# RESPONSE TO SUBMISSIONS REPORT

ALEX AVENUE PUBLIC SCHOOL\_SSD\_9368

JUNE 2019  
P4090  
PREPARED FOR DEPARTMENT OF EDUCATION

Figure 1 – Indicative location for temporary car park and drop-off zone

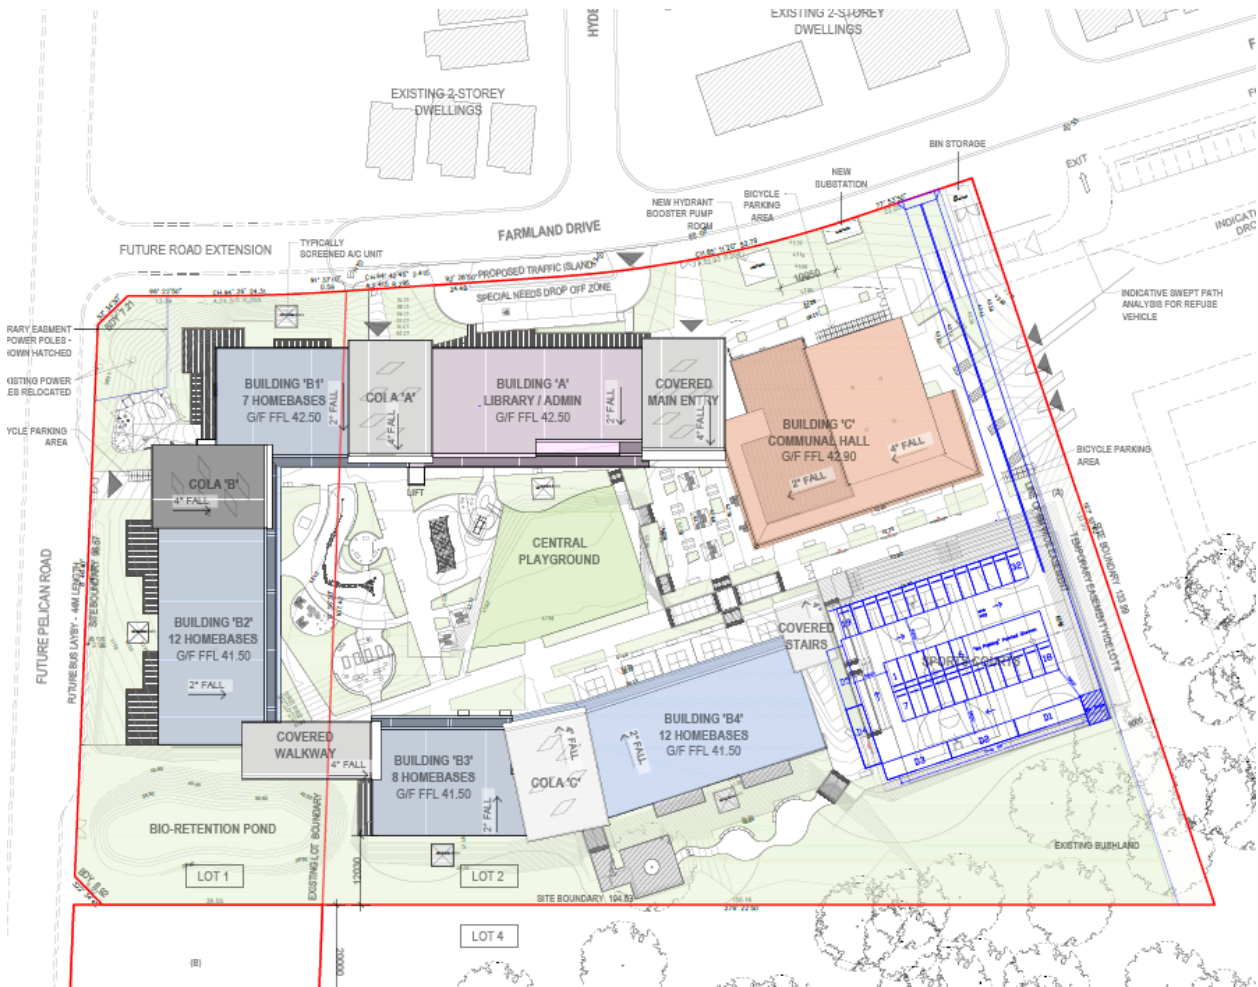
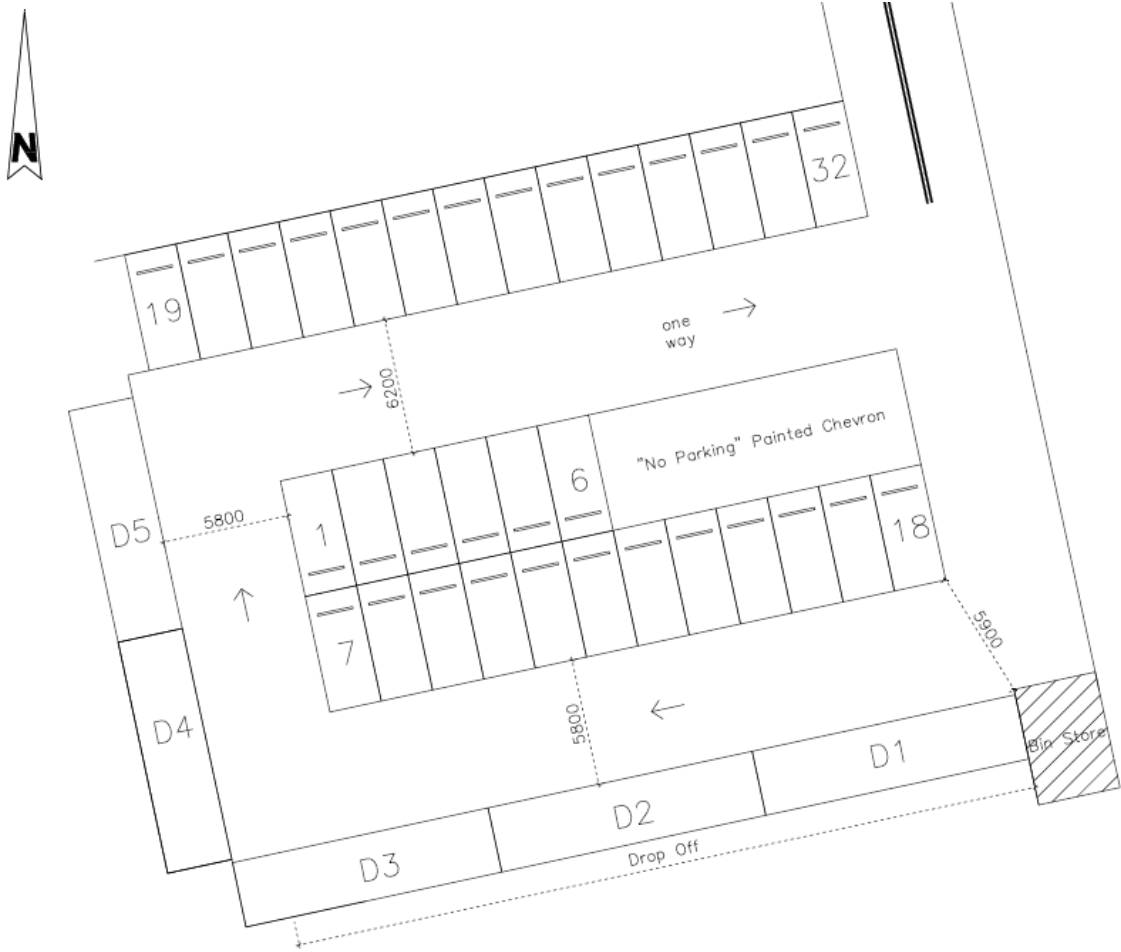
The temporary car park, if required, will be located towards the eastern boundary of the site as shown in **Figure 1** below (roughly within the area of the proposed sports courts). It will also accommodate a provisional waste storage area until the temporary Easement is extinguished, and the bin area can revert to its location near Farmland Drive frontage.

Figure 2 - Indicative layout for temporary car park and drop-off zone

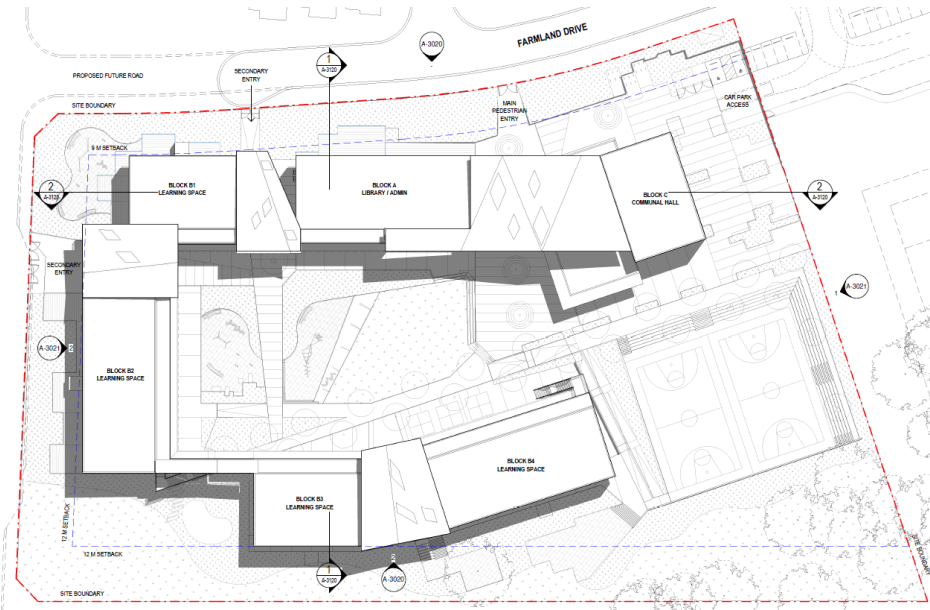
Additional traffic advice has been provided by Bitzios at **Appendix R** which includes an assessment of the temporary parking area against the relevant Australian Standards. This advice also includes temporary car park plans to show the layout of the temporary parking arrangements for Stage 1 of the School's operations. The plans include swept paths to demonstrate that both regular and waste service vehicles will be able to manoeuvre around the temporary parking site as well as enter and exit this area in a forward manner.

Figure 3 – Comparison of Original Site Plan (As Exhibited) and Amended Site Plan

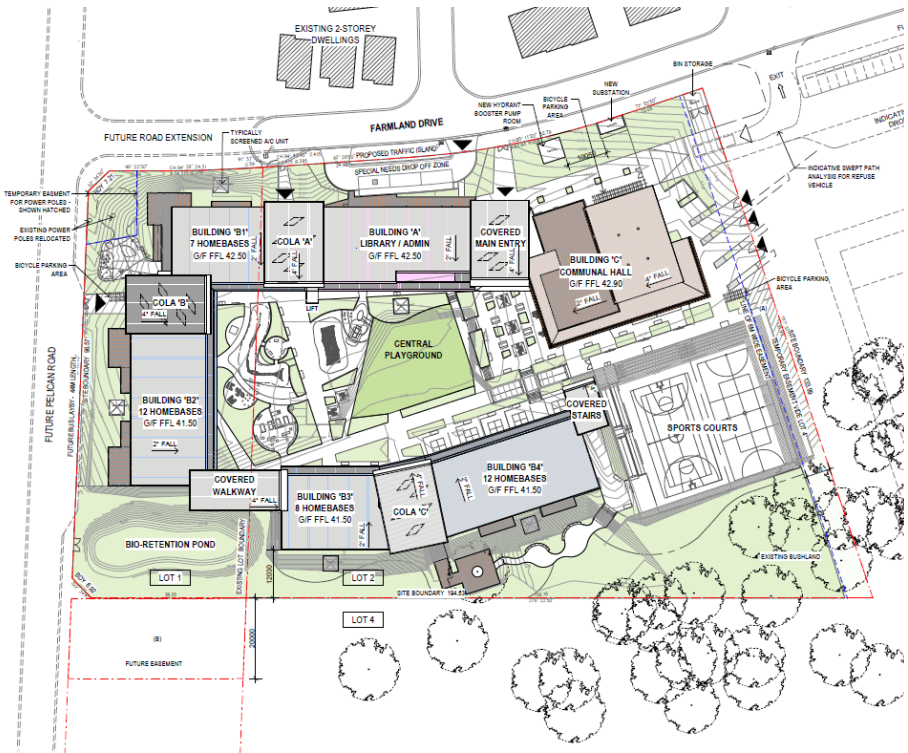
In accordance with Section 55 of the EP&A Regulations, the proposal seeks to make minor amendments to the proposed development. The amendments are a result of design development and in response to agency submissions. The following minor amendments to the original design (as exhibited) are proposed:

- Amendments to building design and internal floor layouts including relocation of external fire stairs and minor changes to the COLAs;
- Relocation of the special needs pick-up and drop-off zone to be contained wholly within the School boundary;

- Provision of a single PWD space within the special needs pick-up and drop-off zone;
- Provision of a temporary 6-metre Easement along the eastern boundary of the site to allow for vehicle access to Lot 4;

- Relocation of all services including the substation, temporary waste bin storage area and PWD parking spaces away from the 6-metre easement;
- Indicative location of a temporary onsite staff car park containing 32 spaces should Council's adjacent car park not be completed in time for the School's opening;

Figure 4 – Comparison of Original Site Ground Floor Plan (As Exhibited) and Amended Site Ground Floor Plan

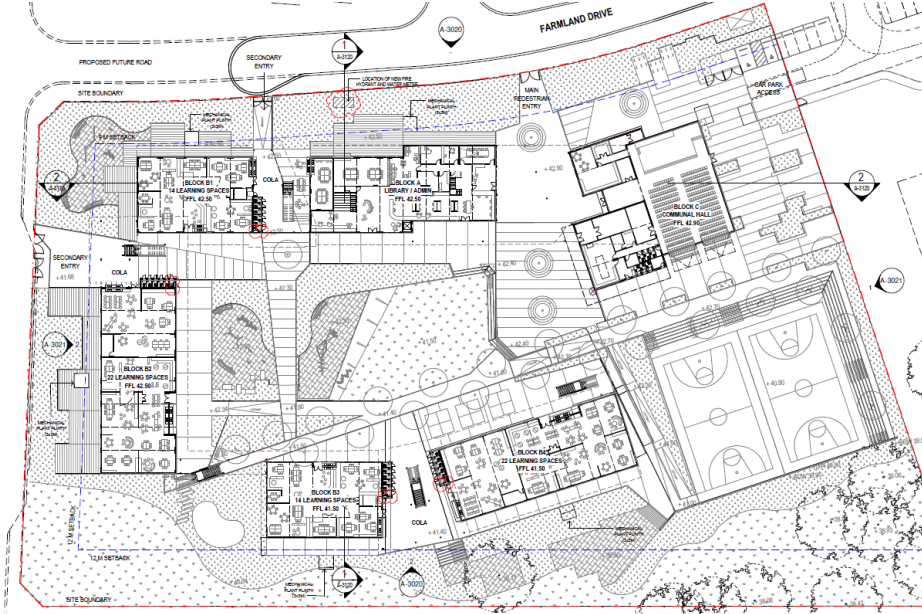
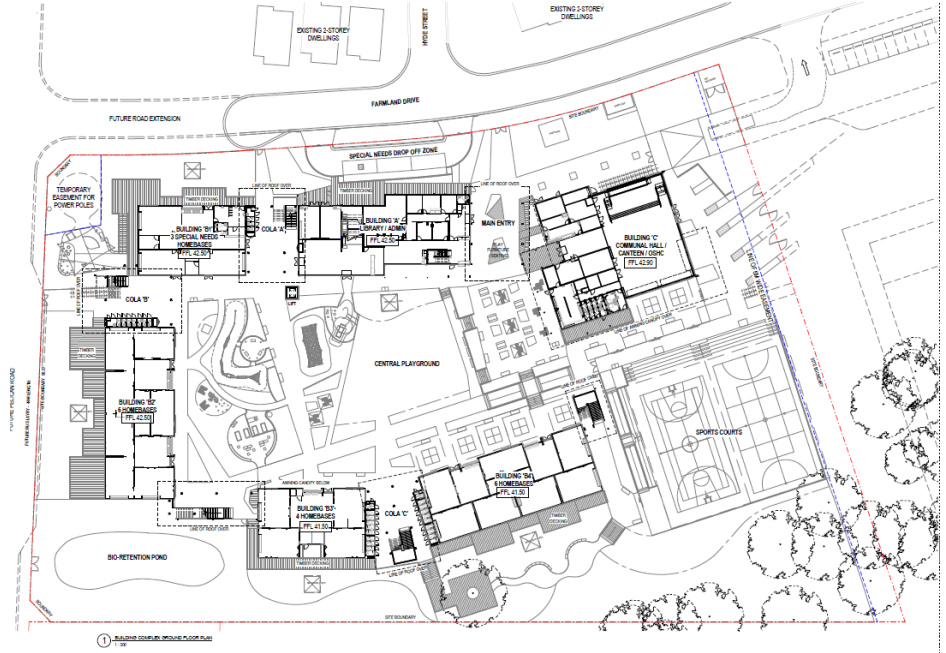
- Relocation of bicycle storage areas to adjacent to the school hall building; and
- Relocation of hydrant booster pump room within the Farmland Drive frontage.
